RE: Swens Canyon Ventilation Facility (SCVF), Canyon Fuel Company, LLC, Skyline Mine,
C/007/0005, Task ID 4935

Title: Swens Canyon Ventilation Facility

Technical Analysis Response to Task ID 4935

DATE: JAN, 2016 CK.BY:TAJ REVISION:
SCALE: 1" = 60' DR.BY:SWF 1
DWG. NO.: 3.2.4-4F SHEET 6

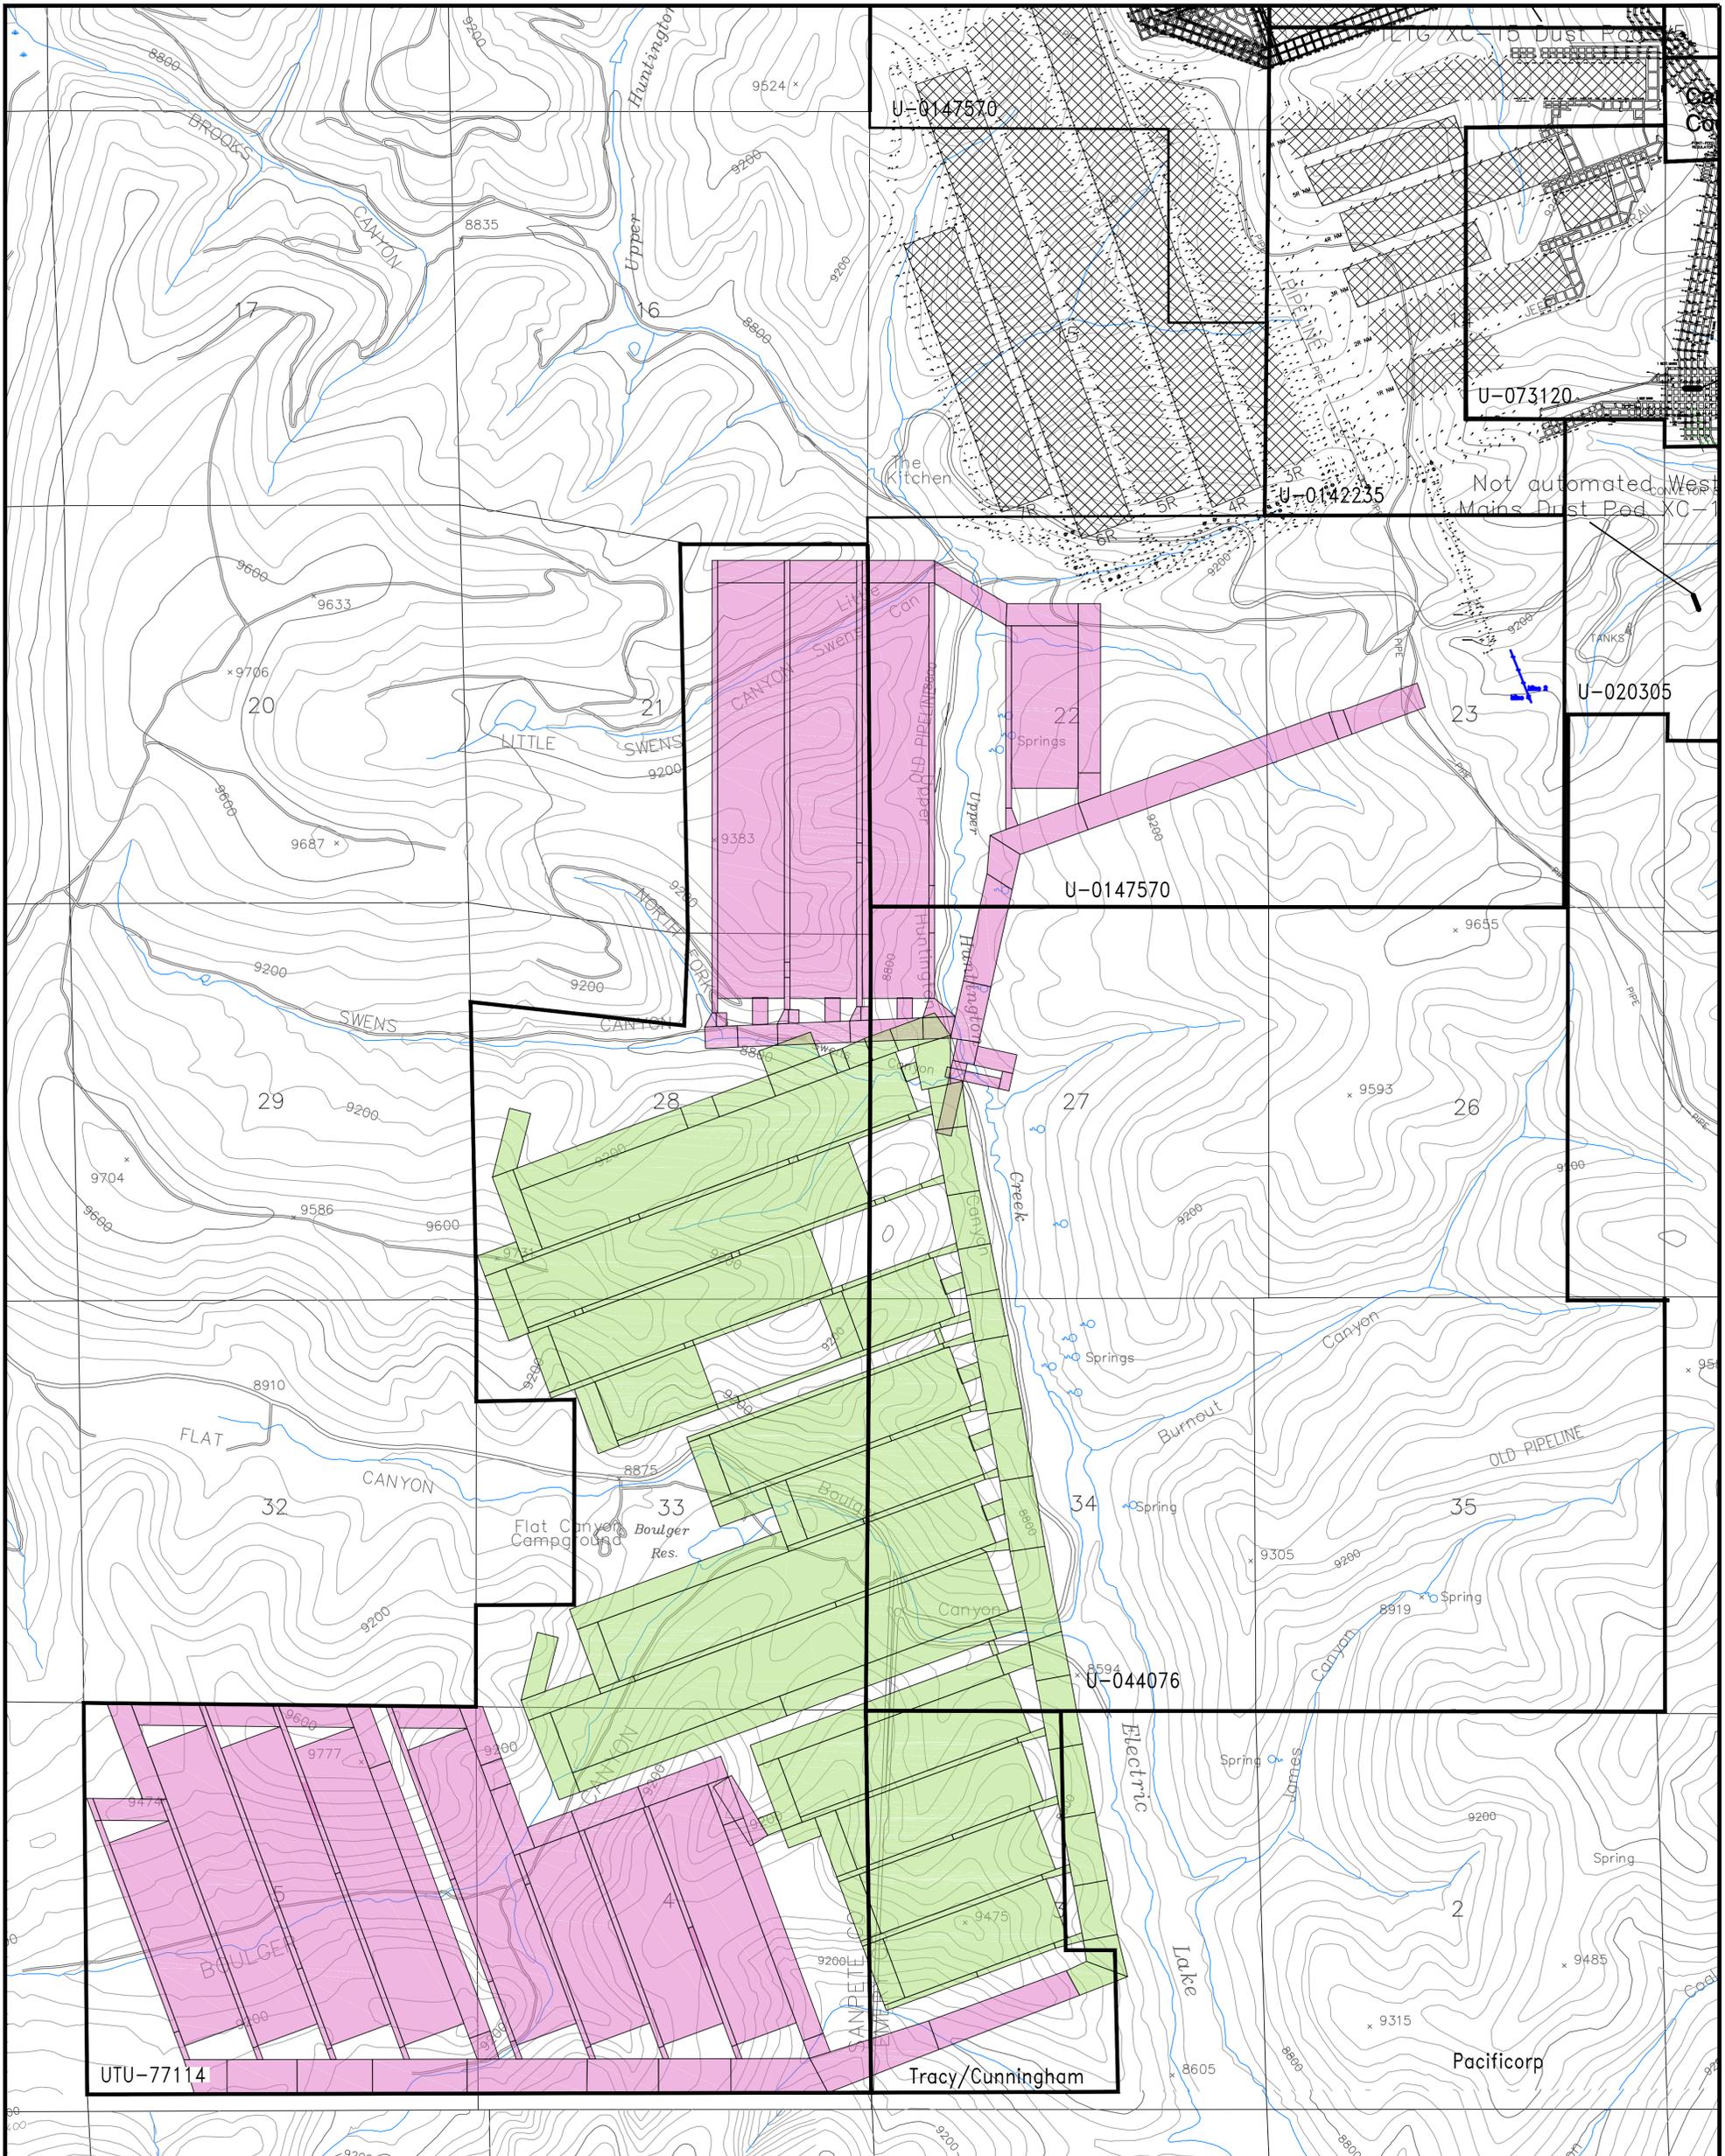
Topsoil and Subsoil R645-301-121.200, -232.300, -234.230, -243, -232.400, -242.200: (pb) Plate 3.2.5-4F was modified to illustrate the amount of topsoil and subsoil removal totals. In general, approximately 1.0-ft of topsoil from the Swens Pad area, (~8,750 cu-yd) and subsoil removal (6,350 cu-yd) totaling approximately 15,100 cu-yd of storage. More detail has been added to page 2-120(m) to describe the protection of the topsoil/subsoil. The two piles will be separated on the pile using orange construction fabric. Table 4.7-11B has been modified to add a nitrogen fixing legume. Section 4.6 Topsoil/Subsoil handling plan has been modified to be consistent with Section 2.11.
